From: Biazar, Shahab
Sent: Friday, May 10, 2013 9:14 AM
To: 'Jeff Mulbery'
Cc: 'Noah Shumate (noahs@dpsdesign.org)'; 'mimib@dpsdesign.org'; Cherne, Curtis
Subject: RE: CNM ATC Project

Regarding to old Motorola site at Alameda between Jefferson and Washington (C17/D9); per our conversation yesterday, and your phone message, it is our understanding that COA Hydrology will not require a Grading and Drainage Plan submittal for the removal of approximately 1 acre of sod and replacement with rock mulch/xeriscaping.

DEMOLITION PLAN
95% REVIEW - CONSTRUCTION DOCUMENTS
ATC TURF REMOVAL AND LANDSCAPE RENOVATION
CENTRAL NEW MEXICO COMMUNITY COLLEGE - ATC BUILDING
4700 ALAMEDA BLVD NE
ALBUQUERQUE, NM 87113

CNM ATC Building
4700 Alameda

B2 SOIL REMOVAL IN POND AREA

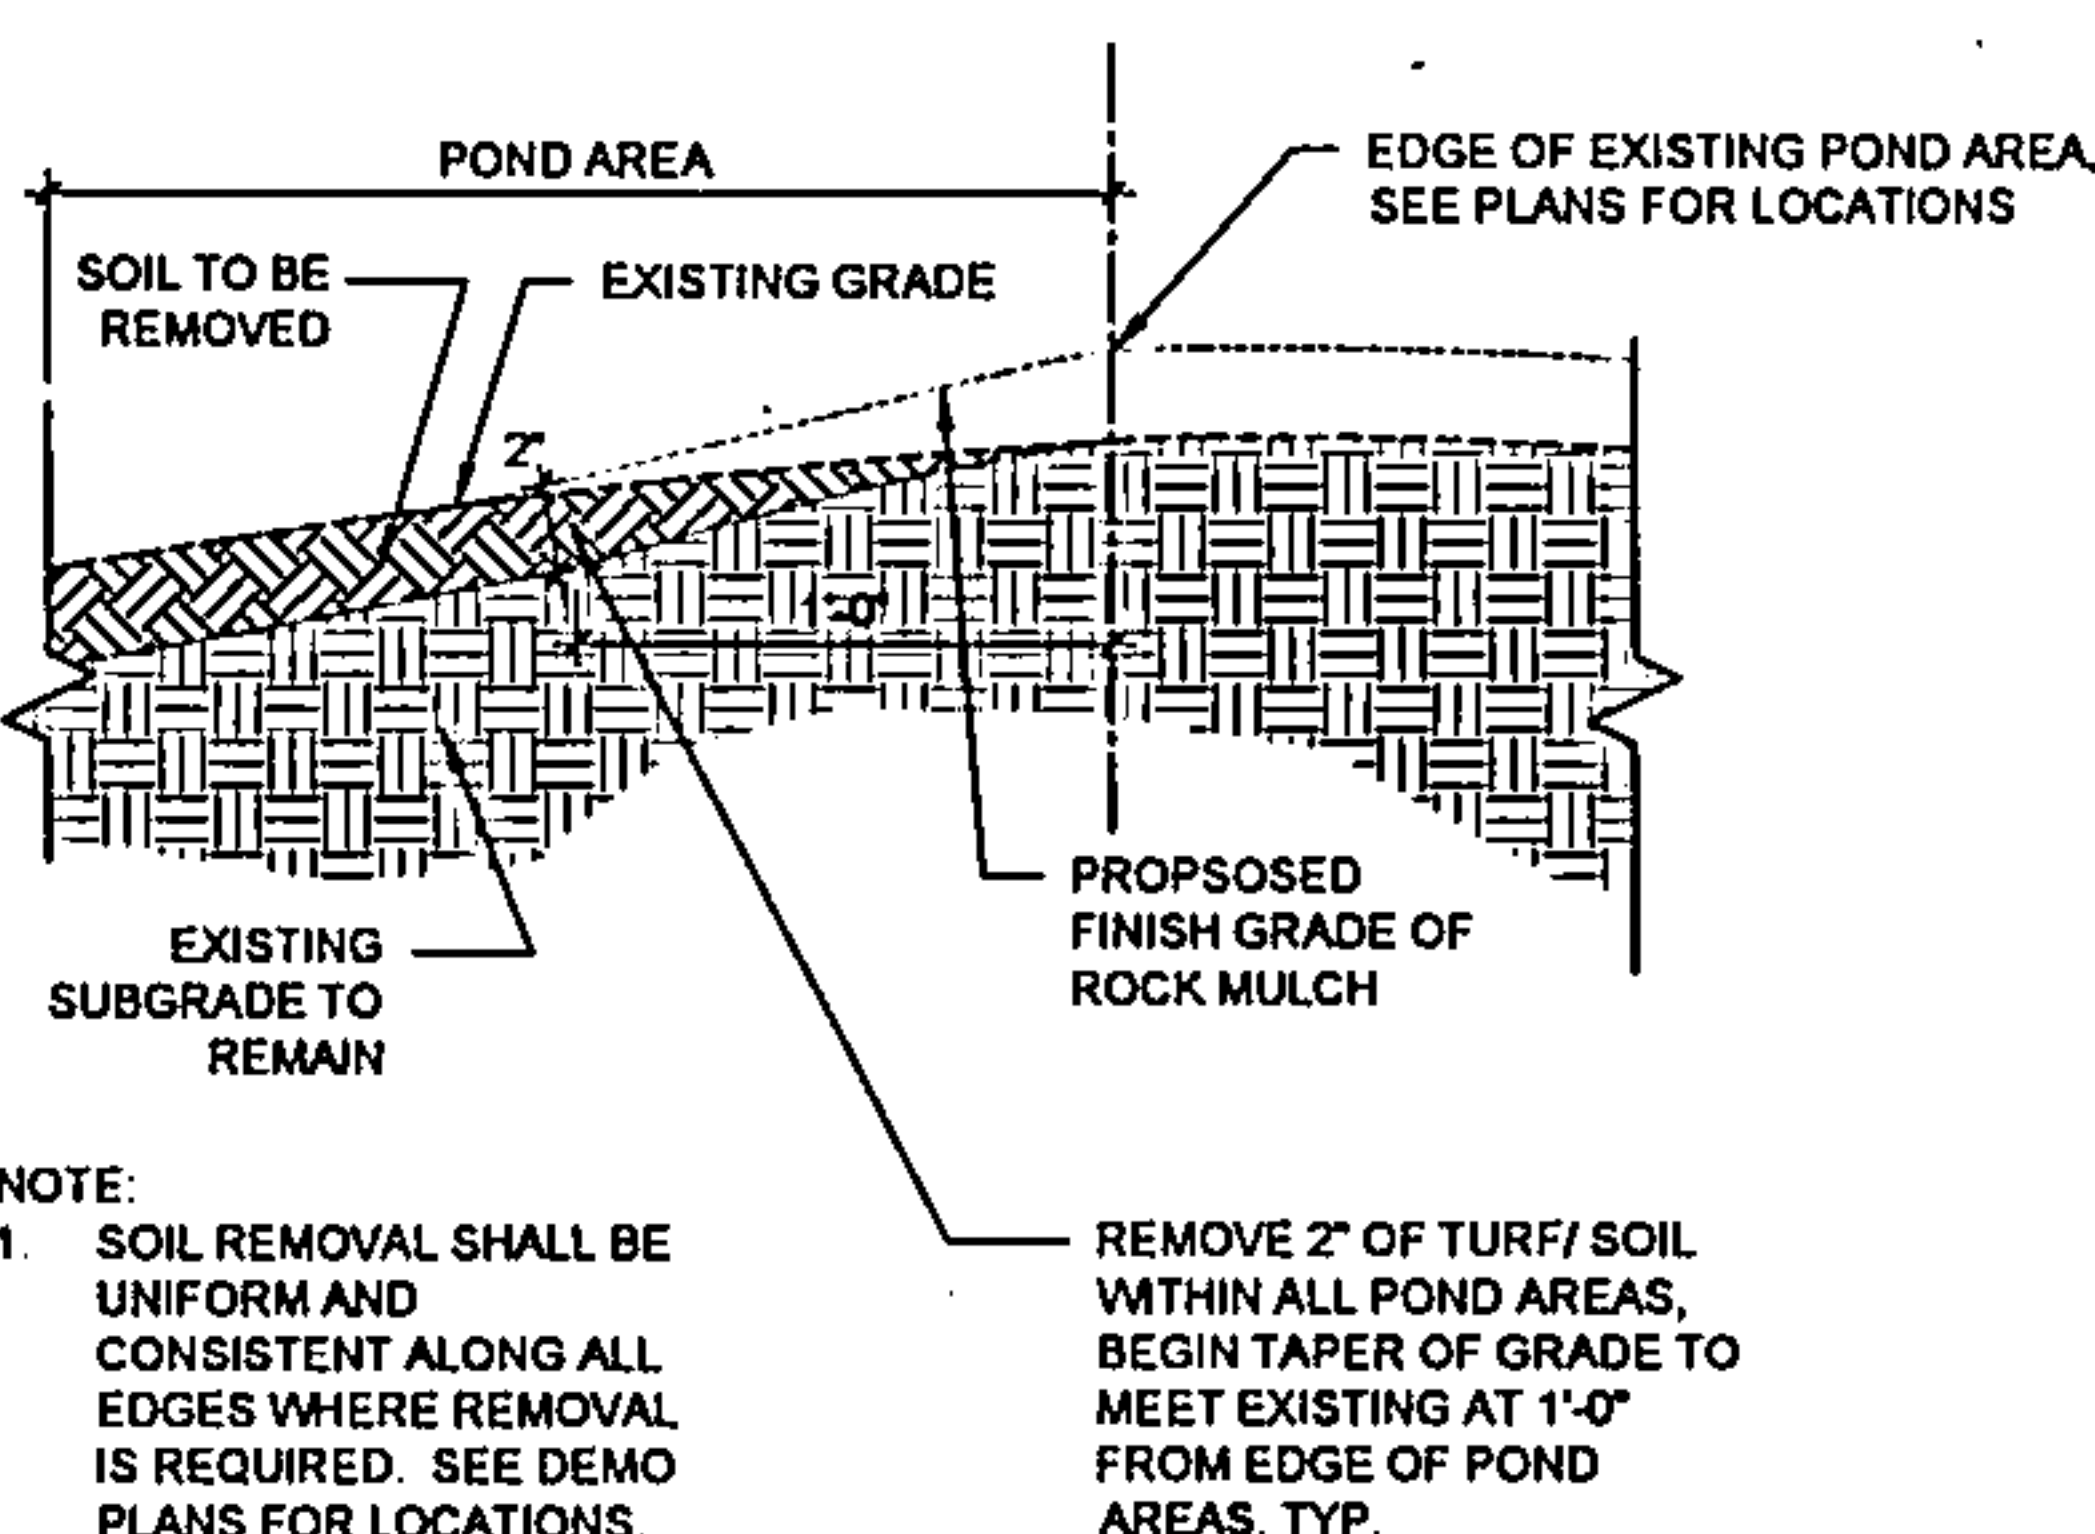
Please also make sure that no volume will be lost when placing the landscaping rocks. If you are lowering the bottom of the pond 1" and placing 3" or more of landscaping rocks or placing more on the slopes that what is coming out may reduce the historical ponding volume.

The finished grade along the top of the ponds shall remain the same. The finished grade of the bottom of the pond shall remain the same, or preferably be lowered by an 1" or so in strategic places. Also, Water Harvesting will be designed into the project, especially at the upper level, where appropriate and useful.
